Serial No. 17-010
NRA/WDC R0
Docket Nos. 50-336/423
License Nos. DPR-65
NPF-49

DOMINION NUCLEAR CONNECTICUT, INC.
MILLSTONE POWER STATION UNITS 2 AND 3
RESPONSE TO REQUEST FOR ADDITIONAL INFORMATION REGARDING END OF
CYCLE 23 AND END OF CYCLE 17 STEAM GENERATOR TUBE INSPECTION
REPORTS (CAC NOS. MF8507 & MF8506)

**RESPONSE TO REQUEST FOR ADDITIONAL INFORMATION REGARDING MPS2
END OF CYCLE 23 STEAM GENERATOR TUBE INSPECTION REPORT**

**RESPONSE TO REQUEST FOR ADDITIONAL INFORMATION REGARDING MPS3
END OF CYCLE 17 STEAM GENERATOR TUBE INSPECTION REPORT**

**Figure-1
Typical Lattice Grid Configuration**

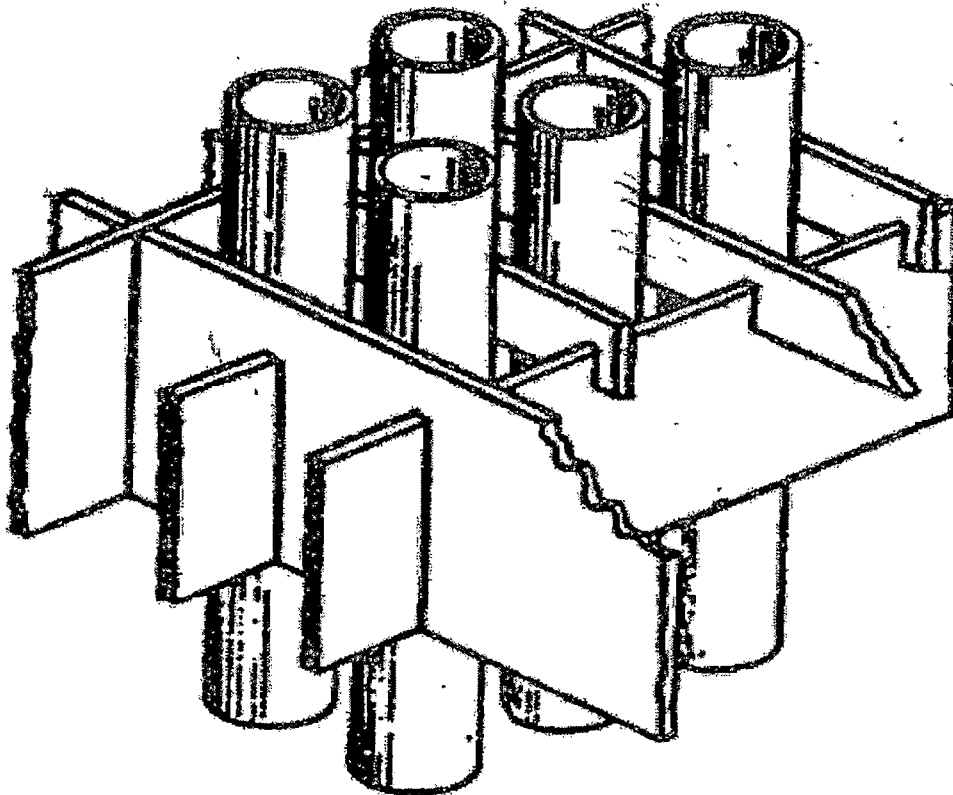
Table 1 states that the "largest fan bar width" is 3.15 inches. Please discuss with further detail to which dimension this is referring (e.g., is this 3.15 inches the largest axial height that a tube is "crossed" by a fan bar?). Does each fan bar have a specific axial height at which it crosses over a tube (because of the angle at which the fan bar goes through the tube bundle)?

The tubes are supported by a number of lattice grids in the vertical (straight) section of the tube bundles as depicted in Figure 1. The configuration of the support/anti-vibration structures in the U-bend section of the tube bundle are illustrated in Figure 2.

Figure-1
Foreign Object Between Blowdown Piping and Tube R1C4

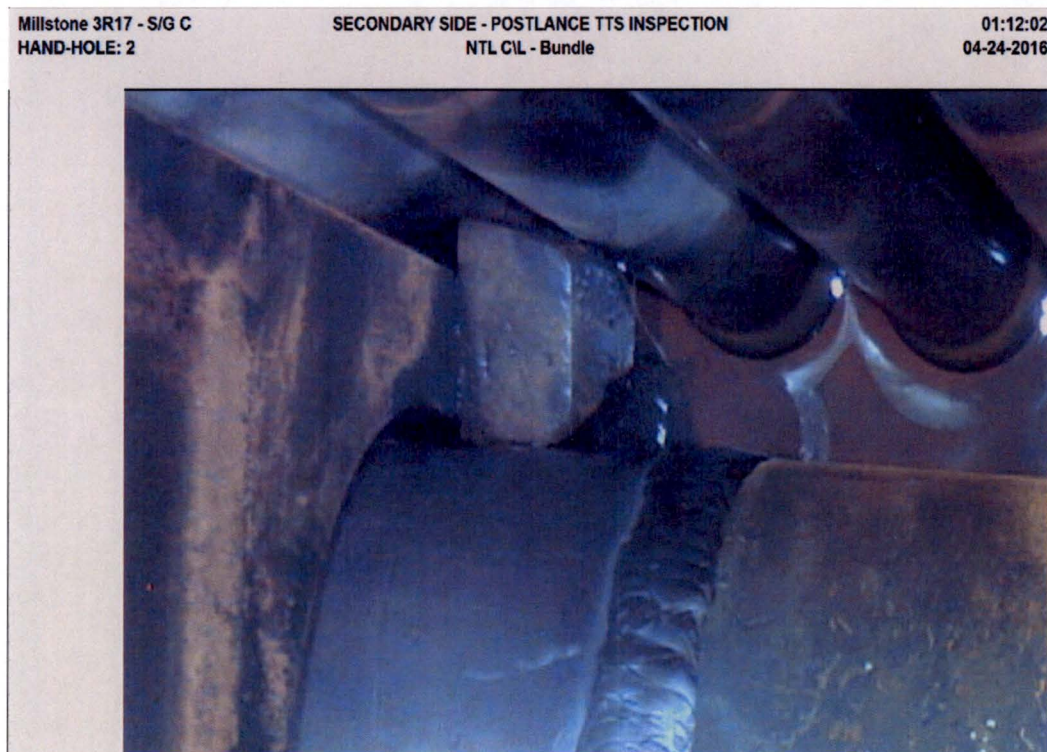
- a. The results of the post-sludge lancing visual examination of the TTS annulus and no-tube lane: If any foreign objects were visually identified and left in service, please discuss whether an evaluation was performed to confirm that the foreign objects would not challenge the integrity of the steam generator tubes for the period of time until the next inspection.*
- b. The results of the visual investigation of accessible locations having eddy current indications potentially related to foreign objects: If any foreign objects were visually identified and left in service, please discuss whether an evaluation was performed to confirm that the foreign objects would not challenge the integrity of the steam generator tubes for the period of time until the next inspection.*
- c. The results of the secondary side upper internal examinations within SG B: was any degradation observed?*

In the four MPS3 SGs, only one foreign object, which was first observed and evaluated during 3R8 (2002), remains in steam generator C. The foreign object is a block of metal lodged between the blowdown piping and tube R1C4 on the cold leg side (Figure-1). Tube R1C4 was plugged and stabilized during 3R8. The existence of this foreign object is confirmed to be confined at this location during every secondary-side visual examination.
